NORTHEAST UTILITIES

Docket No. 50-423
B10845

Millstone Nuclear Power Station, Unit No. 3:
Response to Select Requests for Additional Information

NRC Letter: May 3, 1983

FIGURE 8.3-5
POWER SUPPLY
THIRD REACTOR PLANT
COMPONENT COOLING PUMP
MILLSTONE NUCLEAR POWER STATION
UNIT 3
FINAL SAFETY ANALYSIS REPORT

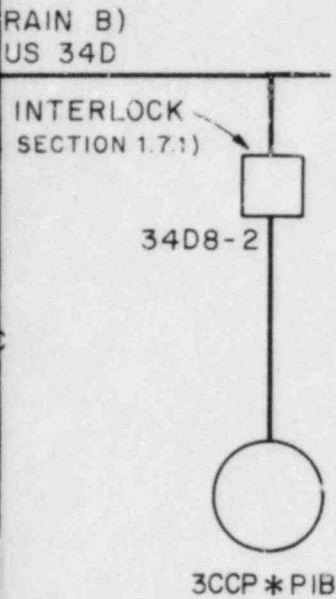
Question No. Q430.31 (SRP Sections 8.3.1 and 8.3.2)

Refer to revised FSAR Section 8.3.1.1.2 and revised FSAR Figures 8.3-4 and 8.3-5 for the response to this question.

Power for running the third reactor plant component cooling water pump is supplied from either emergency bus 34C (Train A) or 34D (Train B) (Figures 8.1-1 and 8.3-5). A manually-operated transfer switch is provided to connect the pump to the selected bus. A feeder breaker cubicle is provided on each bus for connection to the transfer switch. Normally, the breaker cubicle in bus 34D will have a breaker installed; however, the breaker cubicle in bus 34C will not have a breaker installed. Upon failure of, or during required maintenance of the Train A connected reactor plant component cooling water pump, the breaker installed in bus 34D must be removed and installed in bus 34C breaker cubicle. Interlocks are provided to ensure that only one of the third pump power sources can be energized at any one time. Thus, at no time can the two emergency buses be tied together. Additional interlocks are provided to ensure that only one pump on an emergency bus can be energized at any one time.

FIGURE I.2-1
SITE PLAN
MILLSTONE NUCLEAR POWER STATION
UNIT 3
FINAL SAFETY ANALYSIS REPORT

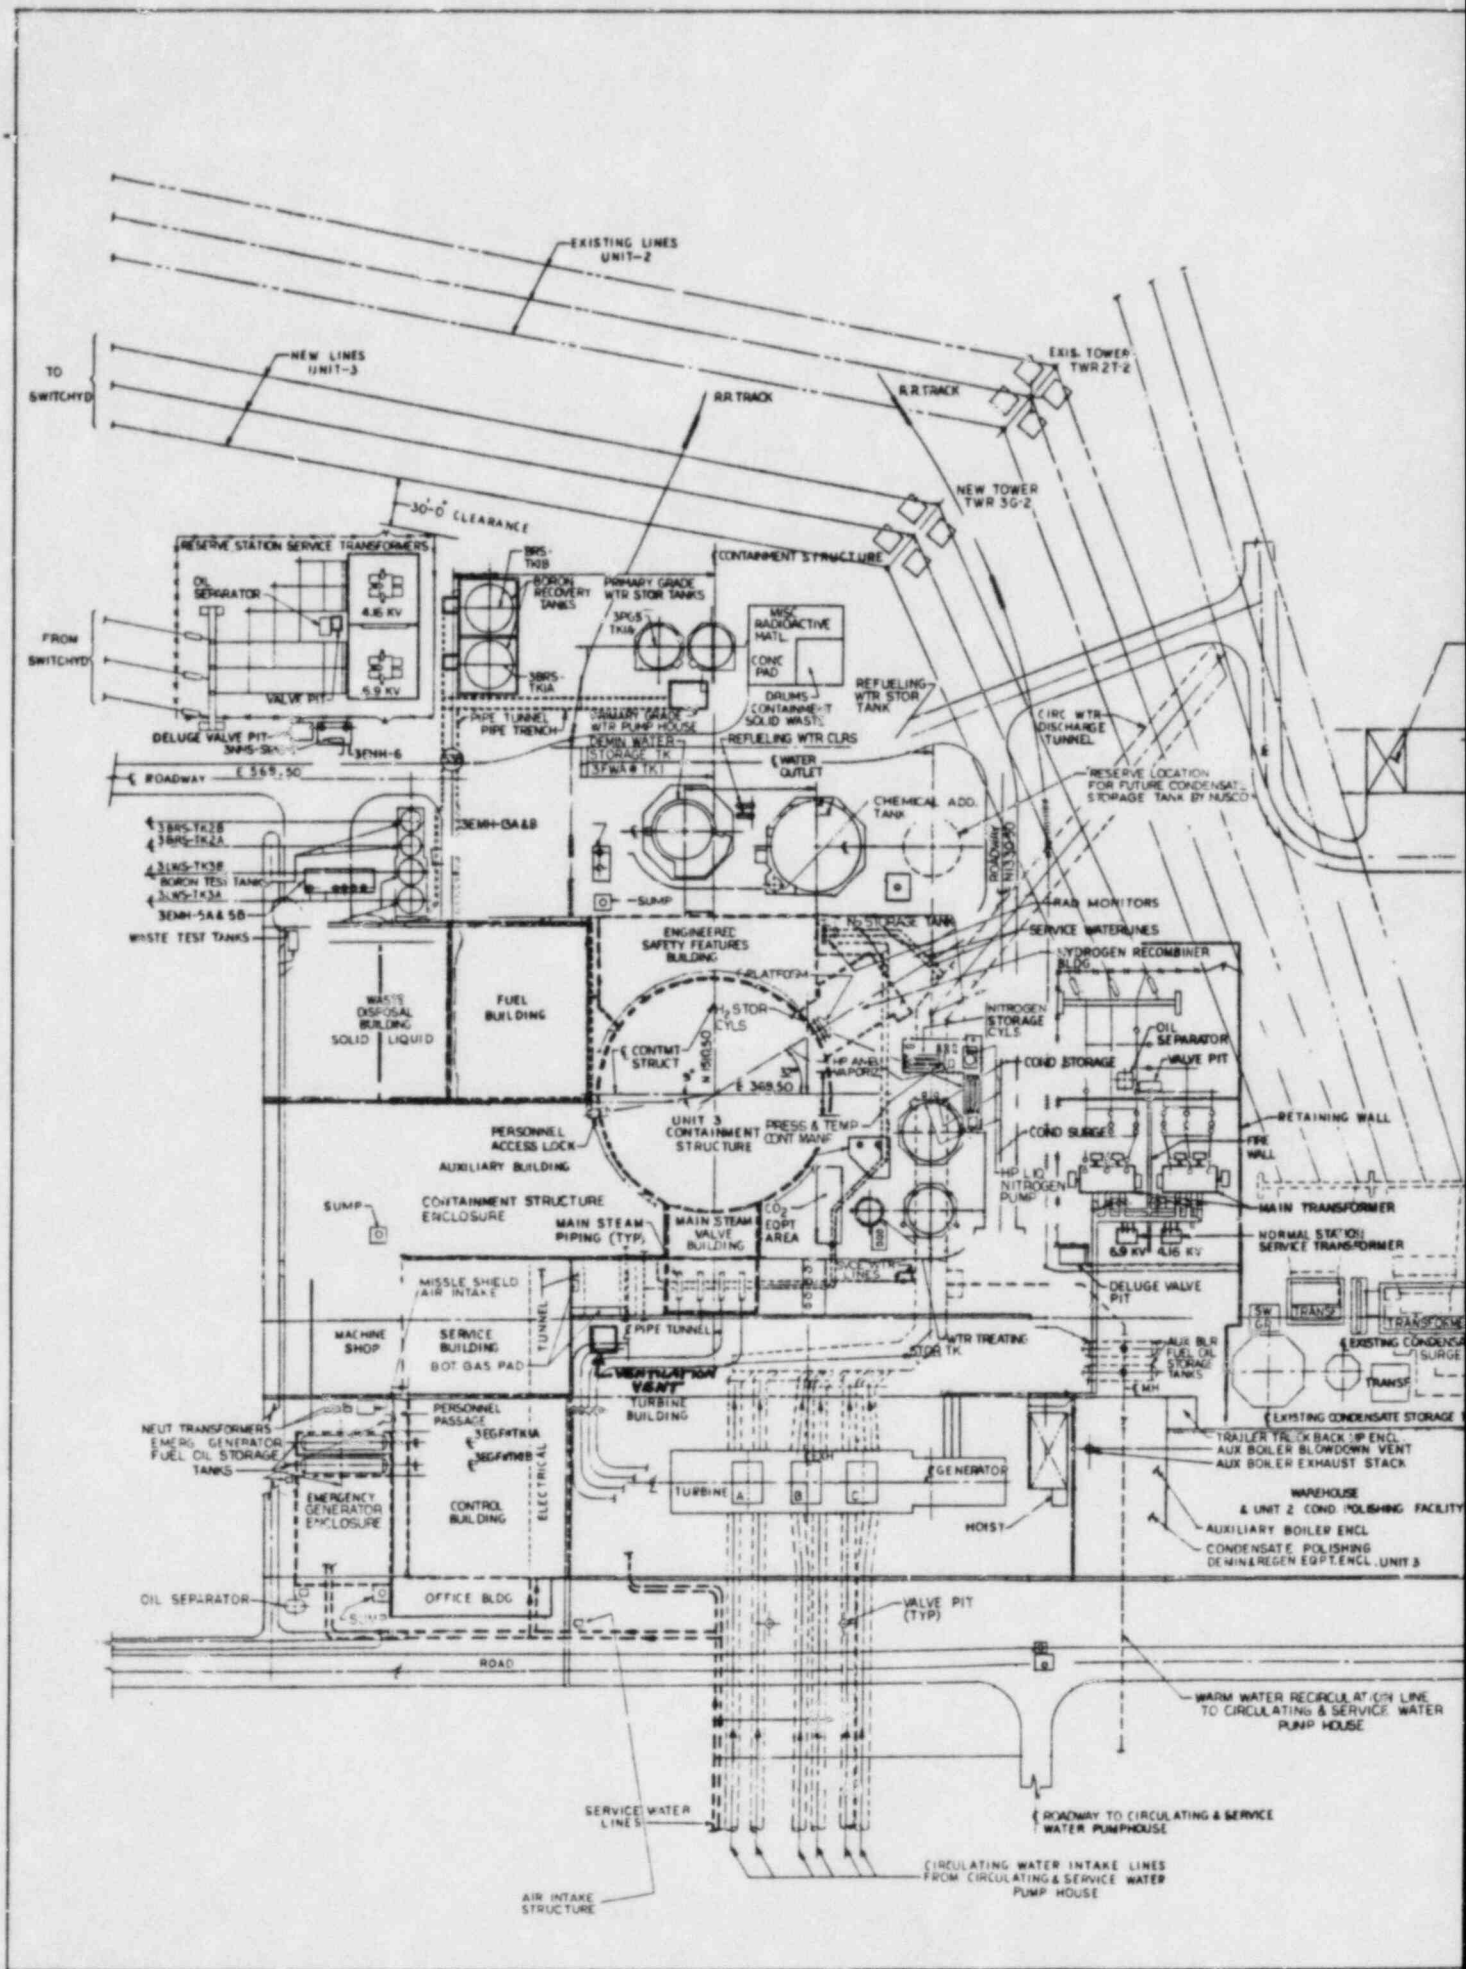
Acceptance Criteria, Requirement II.b, calls for meeting the Positions in Regulatory Guide 1.112. Section 11.3.3 of the FSAR states that the release points are indicated on Figure 1.2-1. Clarify if this should be Figure 1.2-2. Compare Figure 1.2-2 with Figure 2.1-5 of the ER. Provide the information requested in Appendix B to Regulatory Guide 1.112, item 6d, for the height and location relative to adjacent structures. Include the turbine building, warehouse, steam relief vents, and outside tank vents, for example. Provide some detail on how the release lines lead to the stack and the reactor plant vent.

Release points including locations and heights are indicated on revised FSAR Figure 1.2-1 and Figure 1.2-2. Steam vents and turbine building exhausters are shown on revised FSAR Figure 3.8-73. Radioactive tanks are connected to the reactor plant aerated vent system, as indicated in FSAR Section 9.3.3. Air is taken into tanks through the tank vent, and carried out of the tanks by the aerated vent system to the radioactive gaseous waste system (FSAR Section 11.3.3). Ventilation release for the warehouse is discussed in the response to Question 460.15. Information on release lines to the ventilation vent and the Millstone stack is provided in revised FSAR Section 11.3.3.

FIGURE 9.3-5 (1 OF 1)
 REACTOR PLANT
 GASEOUS DRAINS SYSTEM
 MILLSTONE NUCLEAR POWER STATION
 UNIT 3
 FINAL SAFETY ANALYSIS REPORT

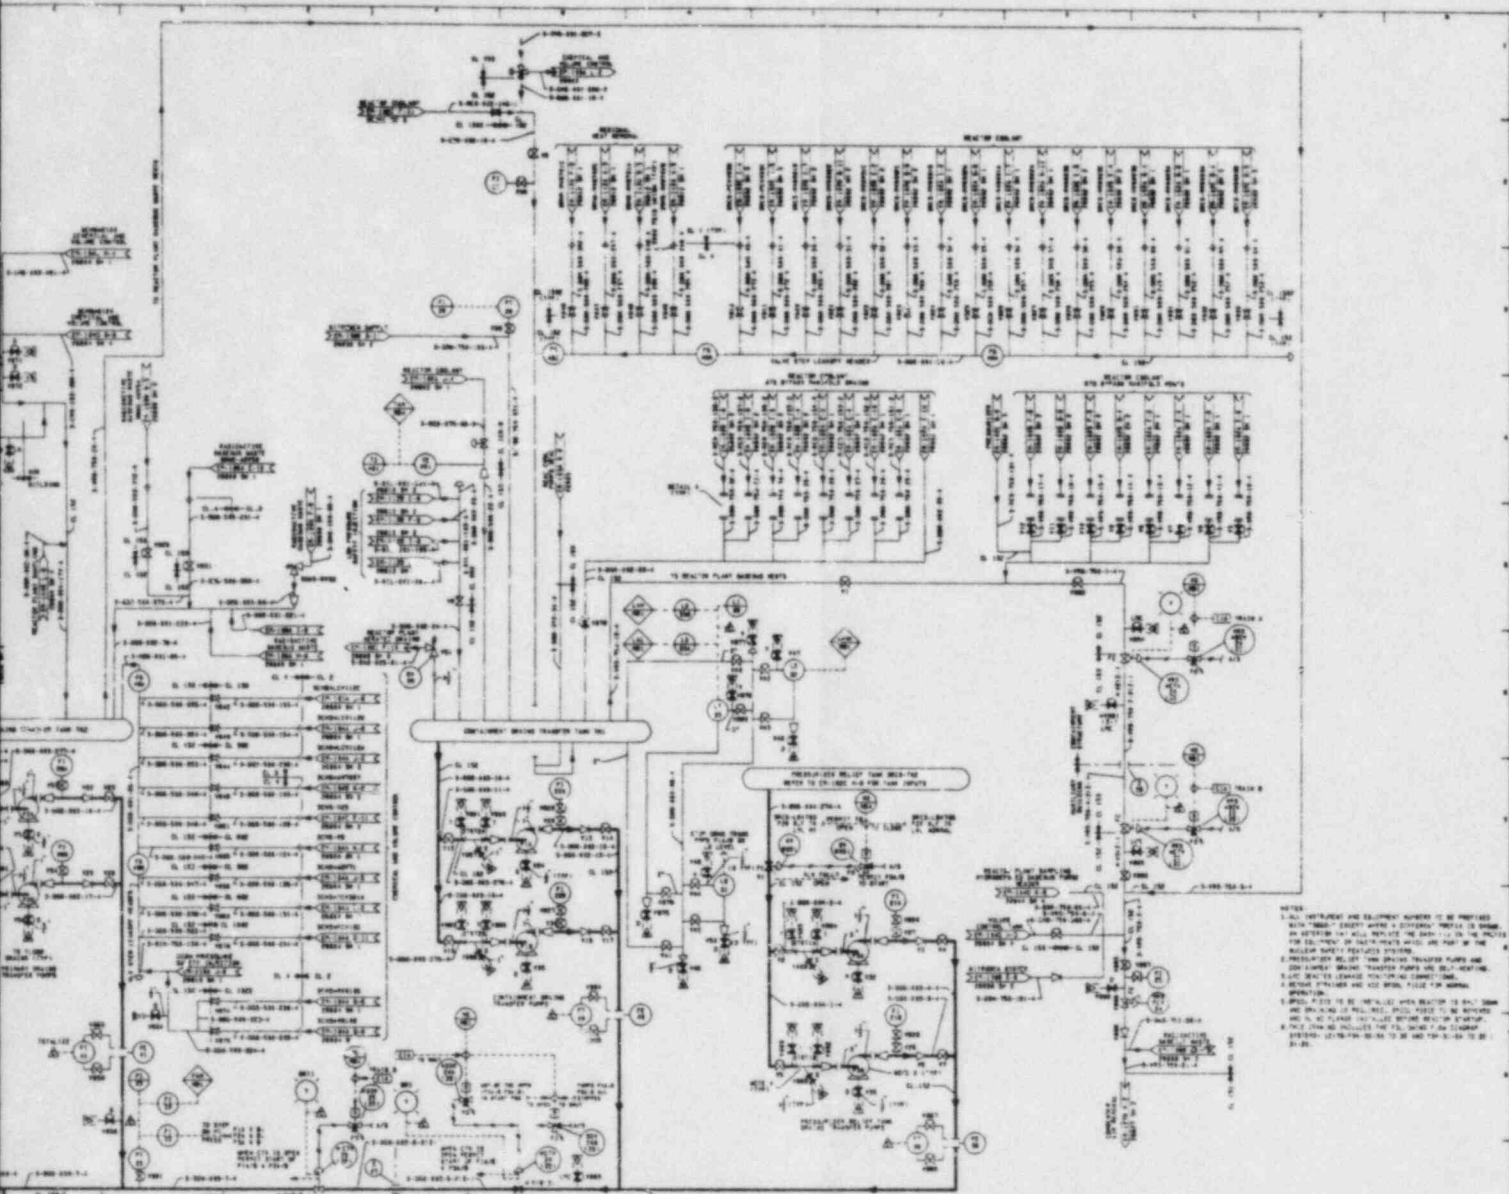
- a. The flow direction of the reactor plant gaseous waste and the condenser air removal lines to the radioactive waste line on Figure 9.3-5 (Sheet 1) at K-9 disagrees with Figure 10.4-2 (Sheet 2) at K-2.
- b. The waste tank inlet and outlet are connected on Figure 9.3-6 (Sheet 1) at K-4 or Figure 11.2-1.
- c. The BRS inlet line EM-109A at E-10 is not shown on Figure 9.3-9 (Sheet 1) at B-2.
- d. Figure 11.5-1 indicates monitor 3HVR-REID. Should this be 3HVR-RE10A and for 10B, as given on Figure 3.8-62 (Sheet 4)?
- e. Figure 9.4-3 (Sheet 2) at I-1 indicates ventilation release to Unit No. 2. How is this line monitored prior to gas release at Unit No. 3?

- a. The apparent disagreement of Figure 9.3-5 (Sheet No. 1), Figure 10.4-2 (Sheet No. 2) and Figure 11.3-1 (Sheet No. 2) has been resolved in revised P&IDs (EM-107A, EM-109B).
